A d d e n d u m

Iowa Department of Transportation
Office of Contracts

Date of Letting: March 19, 2013
Date of Addendum: March 15, 2013

Make the following changes to plan IM-035-2(336)65--13-91:

SS2
SPECIAL

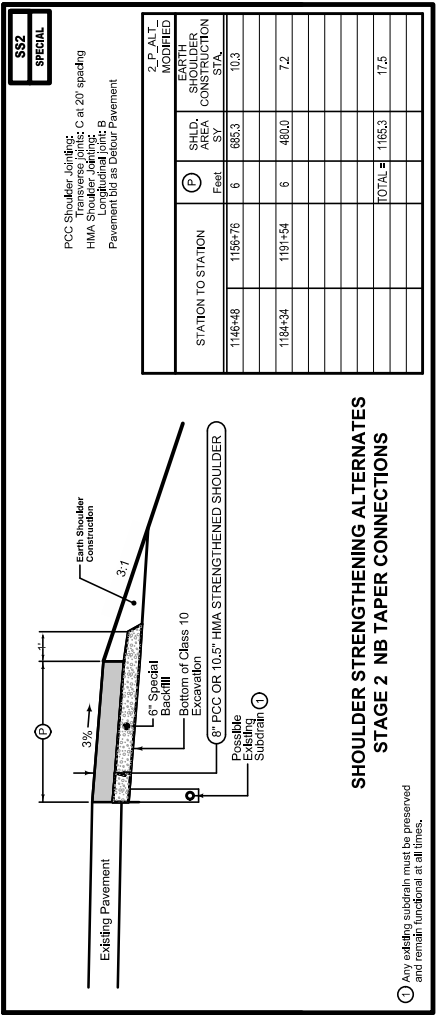
1. Add Typical SS2.
2. Add Typical RAMP DETOUR.
3. Replace sheets B.3 and B.4.
4. Sheet B.5: Typical 1RP_PP: Replace all 12" entries in the T column with 11.5".
5. Add reference notes for the following items:

Items 19 and 24: Also refer to Typical SS2 and Ramp Detour.

PCC Shoulder Joining:
Transverse Joints: C at 20' spacing
HMA Shoulder Joining:
Longitudinal Joints: B
Pavement Bid as Detour Pavement

RAMP DETOUR SPECIAL

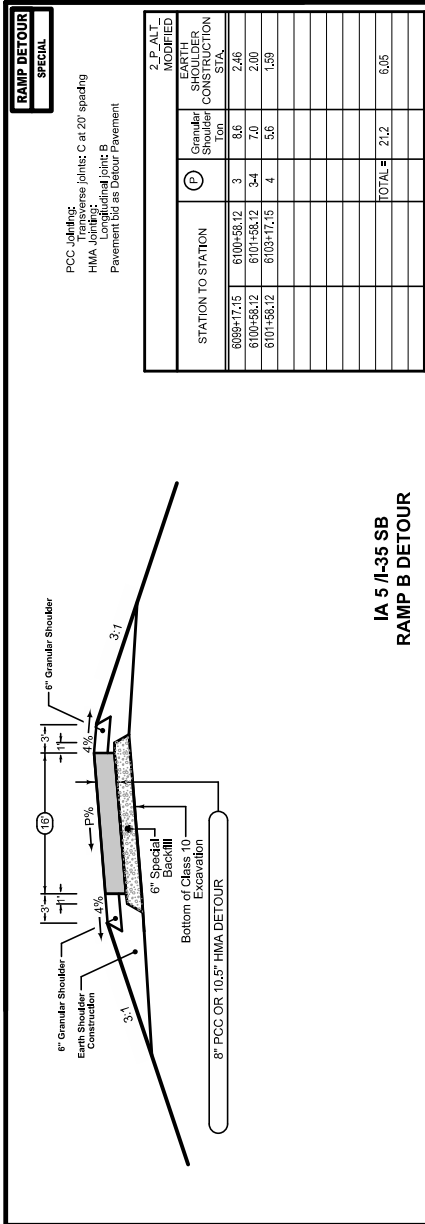
Item 17: Also includes 21.1 tons for Ramp B detour. Refer to Typical Ramp Detour.

Item 89: Also includes removal of detour shown on Typical Ramp Detour. Leave inside shoulder for ramp.

PCC Jointing:
 Transverse joints: C at 20' spacing
 HMA
 Longitudinal joint: B
 Pavement bid as Detour Pavement

| WARREN/POLK COUNTY | PROJECT NUMBER | IM-035-2(336)65--13-91 | SHEET NUMBER | J.23X |

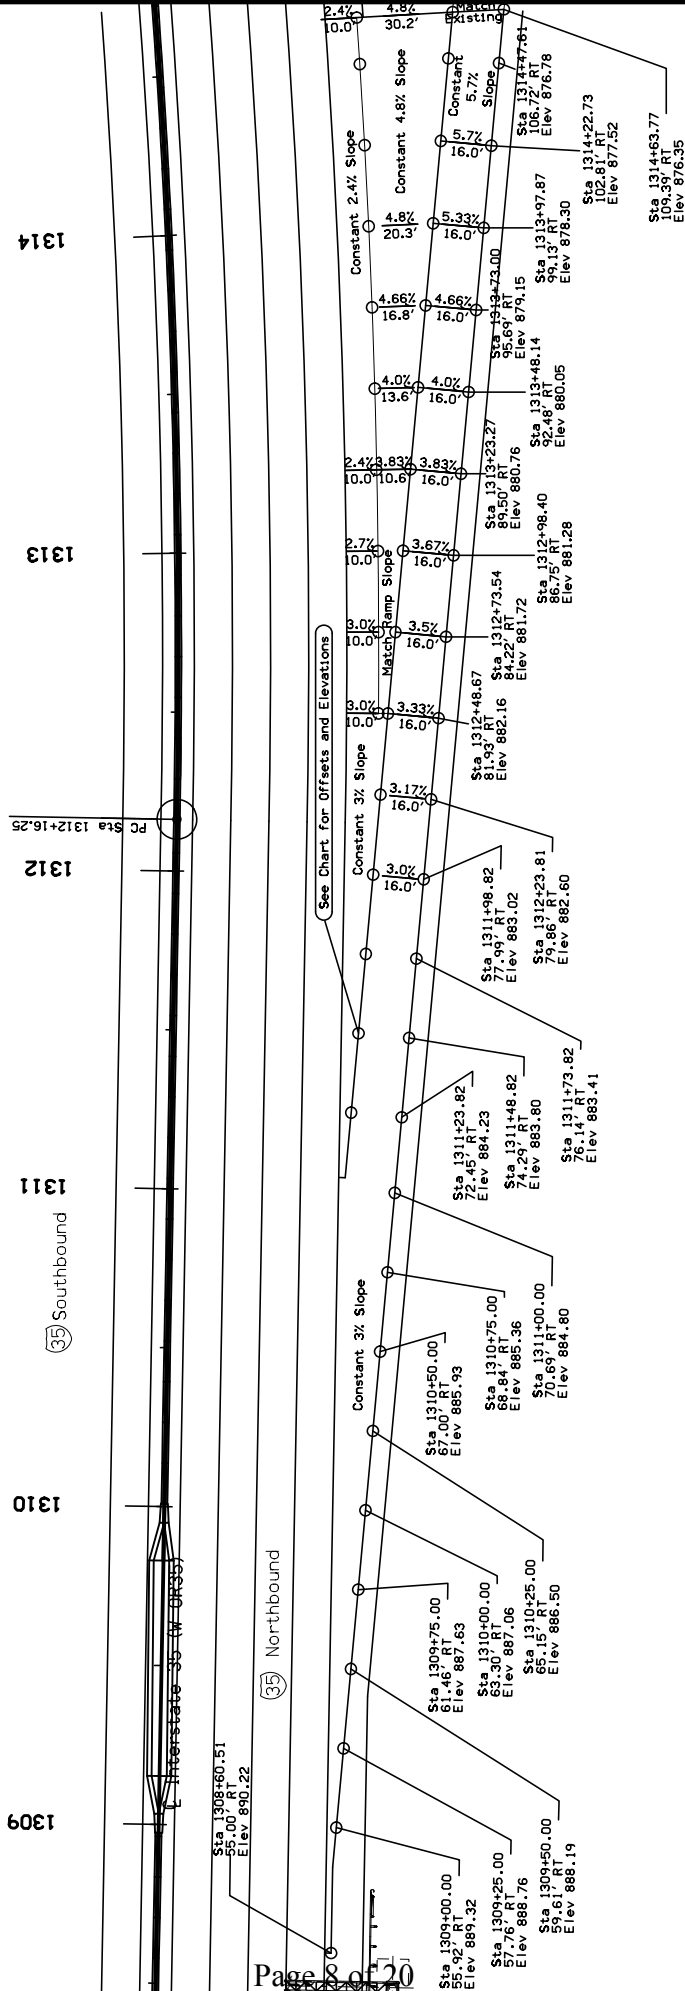
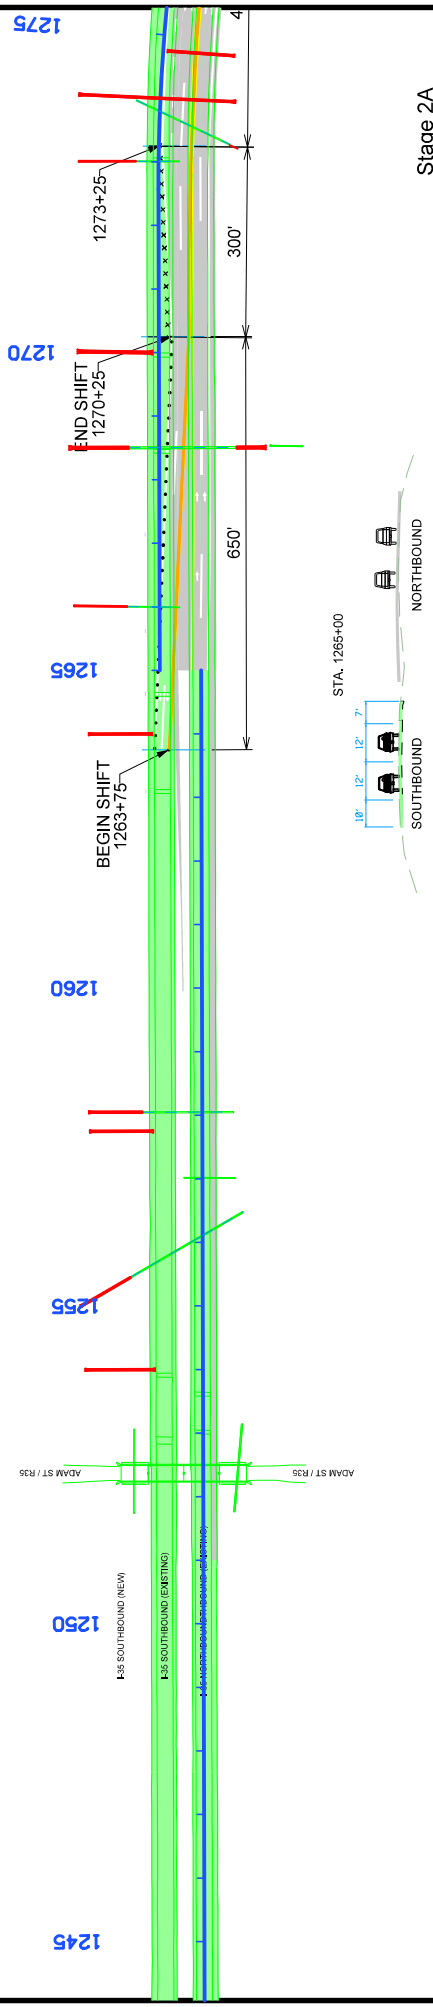
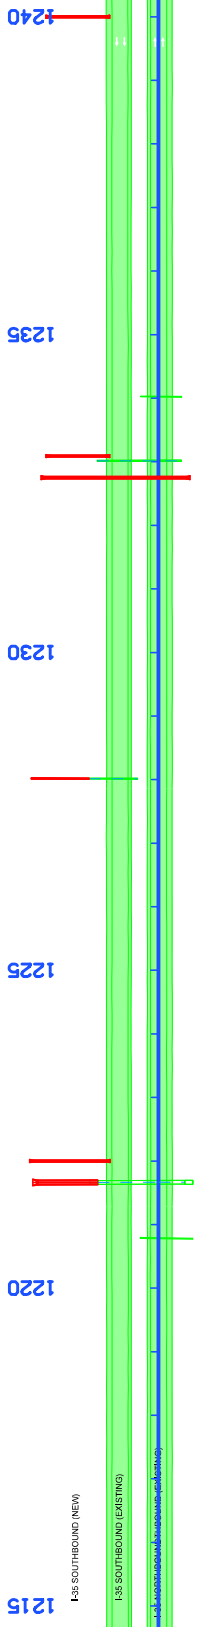
6. Replace Tab. 100-24 with the new tab. 100-24
7. Add new sheets: F.1, F.2, K.13, K.14, U.10
8. Sheet J.1: Remove statement : “During construction at ramps at the IA 5 interchange, ramps may be closed between the hours of 10:00 pm and 5:00 am.
9. Sheet J.2: In Stage 2A Section, under construction, add statement: “Construct detour for IA 5 WB to IA 35 SB entrance ramp.
10. Sheet J.23: Replace with Sheets J.23X, J.23Y, and J.23Z
11. Replace J.24, J.25, J.26, and J.27
